UNITED STATES PATENT AND TRADEMARK OFFICE

APPLICATION NO.	FILING DATE	FIRST NAMED INVENTOR	ATTORNEY DOCKET NO.	CONFIRMATION NO.
09/943,507	08/31/2001	Shigekazu Ohtomo	520.40591X00	8177

Final Rejection

FIG. 12

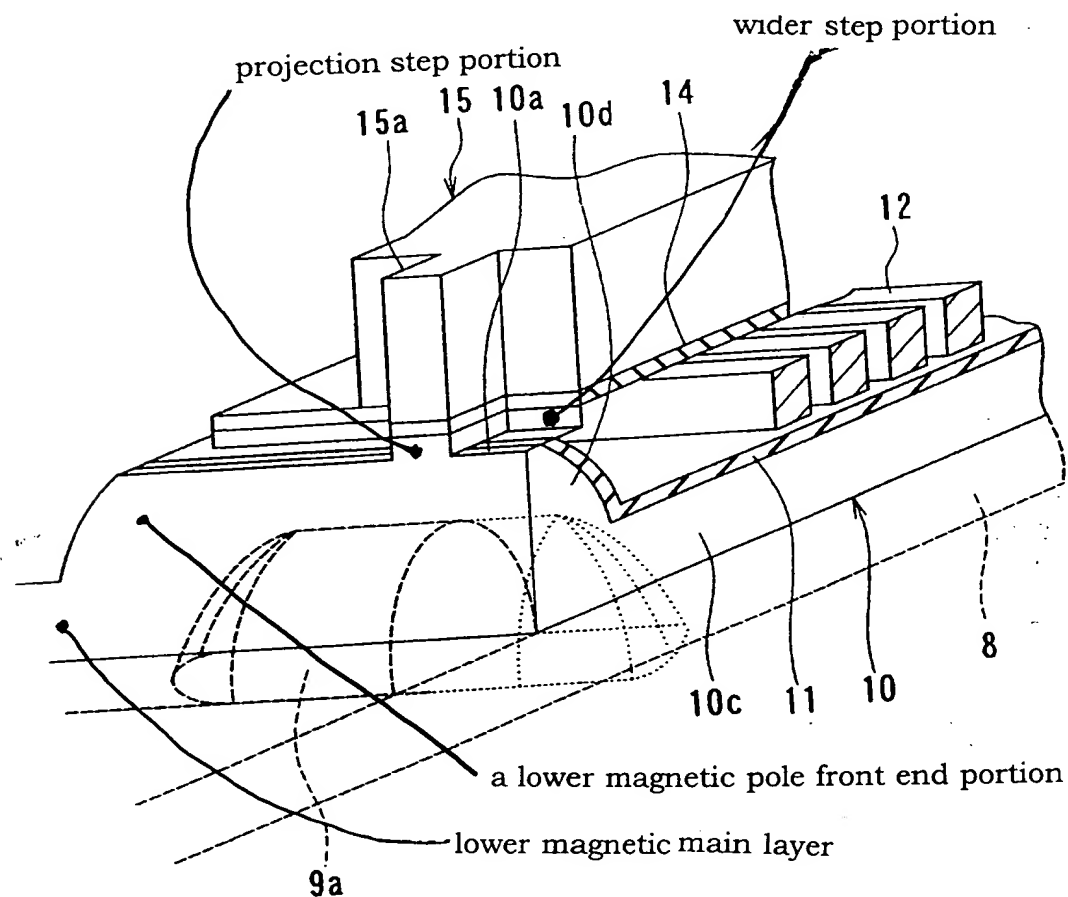
With regard to claims 16 and 20; Kamijima shows a thin film head in Figs. 11 and 12 having a reading part 5 (Column 8, line 34) and a recording part including: an upper magnetic pole 15 (Fig. 12); and a lower magnetic pole having a lower magnetic main layer (See Figure attached), a lower magnetic pole front end portion on the lower magnetic main layer, and a projection step portion on the lower magnetic pole front end portion; wherein the projection step portion has a/a pair of wider step portion(s) at a predetermined depth from an air bearing surface which is wider than a width of the projection step portion at the air bearing surface, the wider step portion being wider than a width in a track direction of the upper magnetic pole at the predetermined depth from the air bearing surface.
